WATER PERMIT NO. 5532-3

Application For Permit To Appropriate Water Within The State Of South Dakota

**SOUTH DAKOTA
WATER PERMIT No. 5532-3**

REPORT ON APPLICATION NO. 5532-3
for McCord Heat Transfer
June 3, 1991

5158 PARK AVE. DES MOINES, IOWA 50321	
PROJECT No: 042109821		DATE: 1/03/91	
DETAILED TITLE:		SITE MAP	
CLIENT: McCORD HEAT TRANSFER DIVISION		LOCATION: CANTON SOUTH DAKOTA	
APPROVED:		CAS DIV. FILE No. 9821-SGB

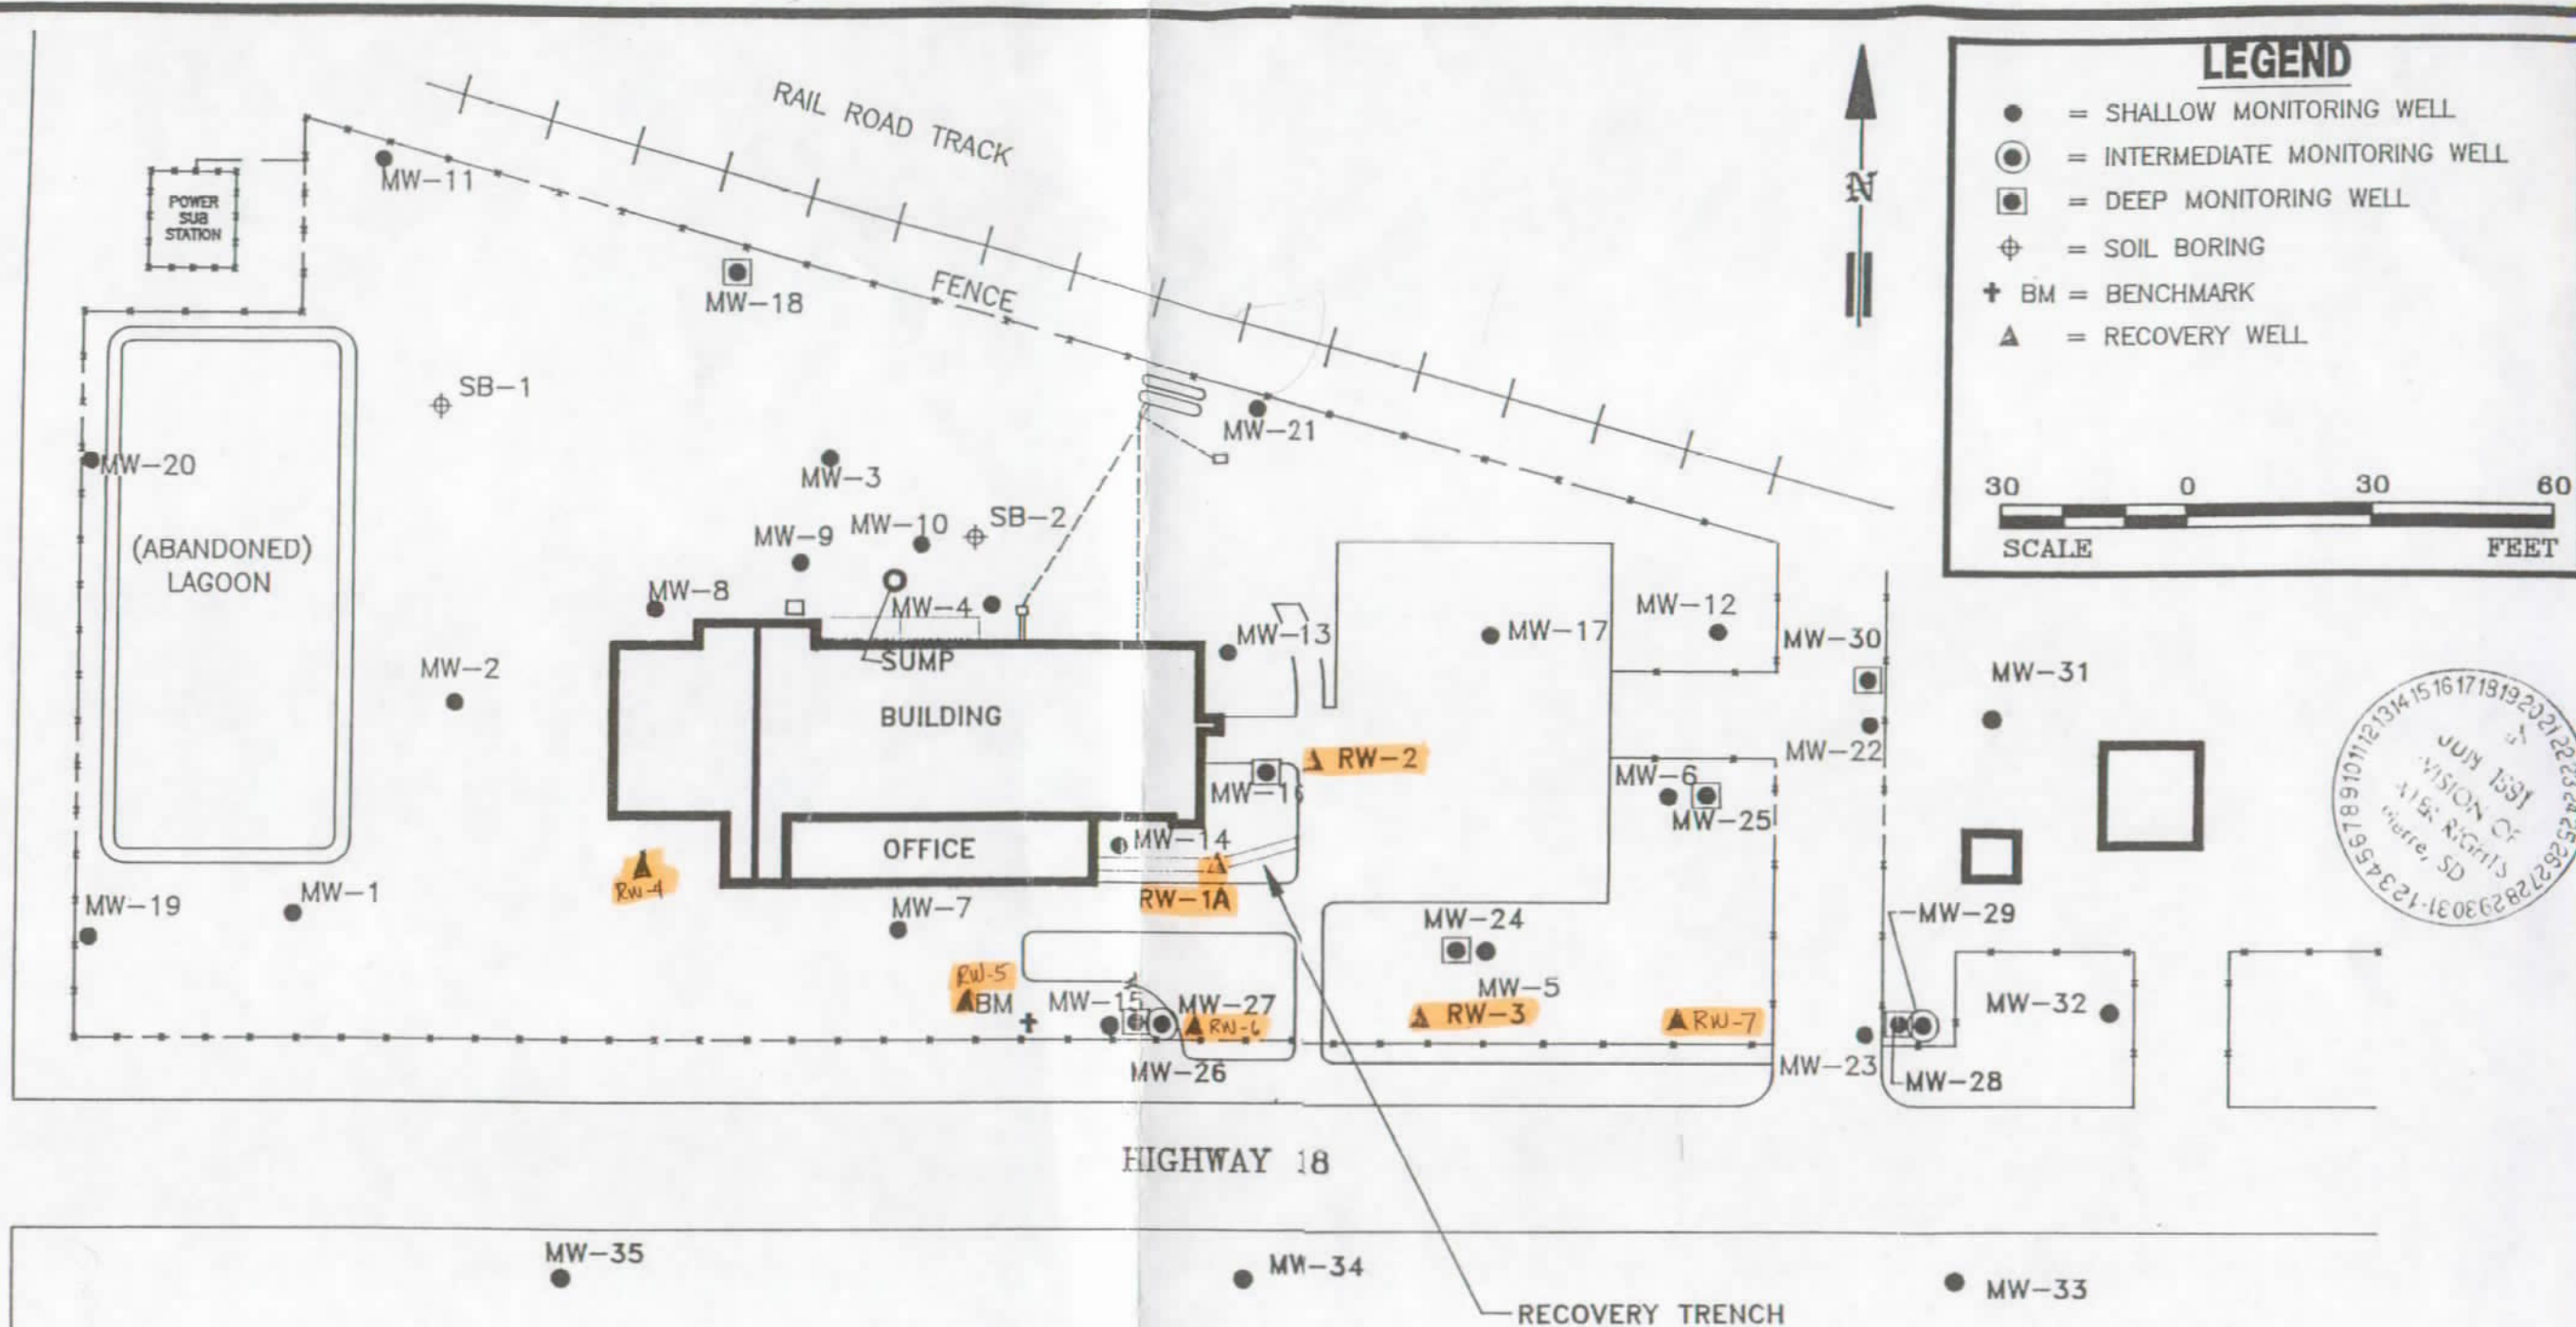
- 2) The enclosed map submitted with the applications needs to be prepared and signed by one of the following persons: 1) A South Dakota registered professional engineer, 2) A South Dakota licensed land surveyor or 3) A government employee that regularly prepares maps as part of his or her duties. If Norman Kennel qualifies for one of these positions, then please have his title placed on the application or someone else will need to prepare and sign the map as outlined on the enclosed instruction sheet.

1. The new map showing the location of the wells must be signed by one of the following: 1) South Dakota Registered Land Surveyor; South Dakota Registered Professional Engineer; or by any government employee who normally prepares maps as part of his assigned duties.
2. The legal description of the location of the wells to the nearest quarter-quarter. The original application stated the one well is to be located in the SW1/4 SW1/4 Section 15, T98N, R49W. Are the additional wells also located within the SW1/4 SW1/4 of Section 15.

2. The location map requires a qualified individuals' signature: A new map is enclosed with the signature of a Registered Professional Engineer. The original map was not signed by a person with the required qualification.

Per your recent request, enclosed is the survey map exhibiting well locations. Specifically recovery wells 1, 2, 3, 4, 5, 6, 7 will be used in remediation. If you have questions please call me at 515-282-9132.

MAP NOT TO SCALE

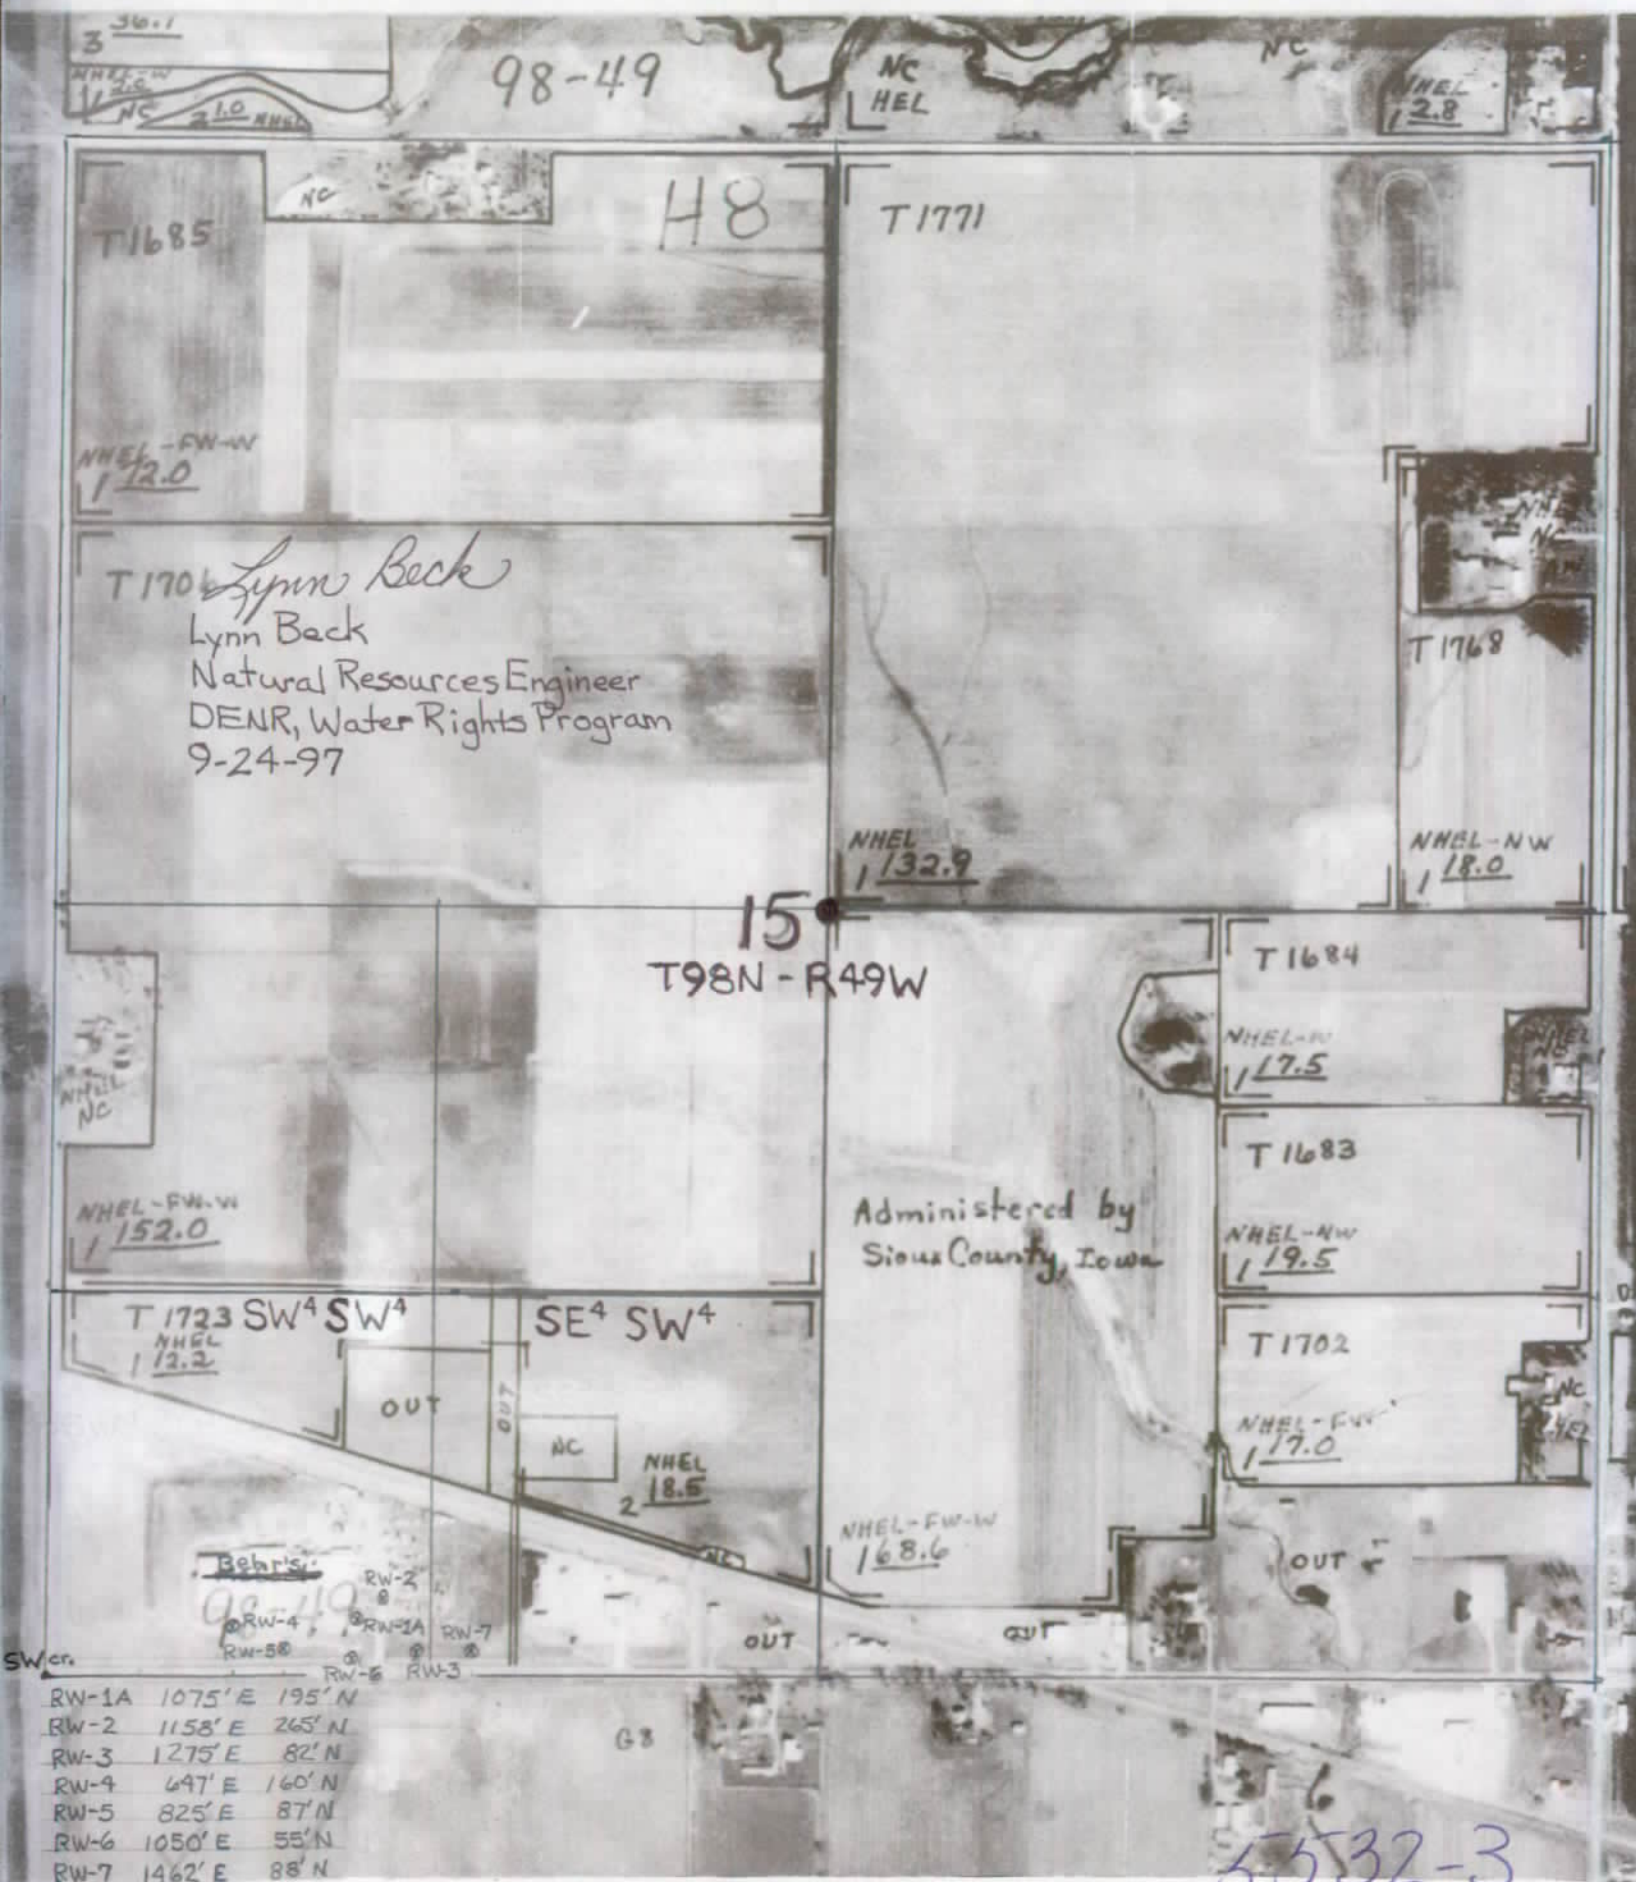
A September 11, 1997, investigation of the water use system found one of the seven wells authorized under Water Permit No. 5532-3 had been developed outside of the permitted area. Pursuant to SDCL 46-5-13.1, the Chief Engineer makes a finding that the change in location of the diversion point does not increase the potential for interference with or impair existing diversions. The overall project is consistent with the original application.
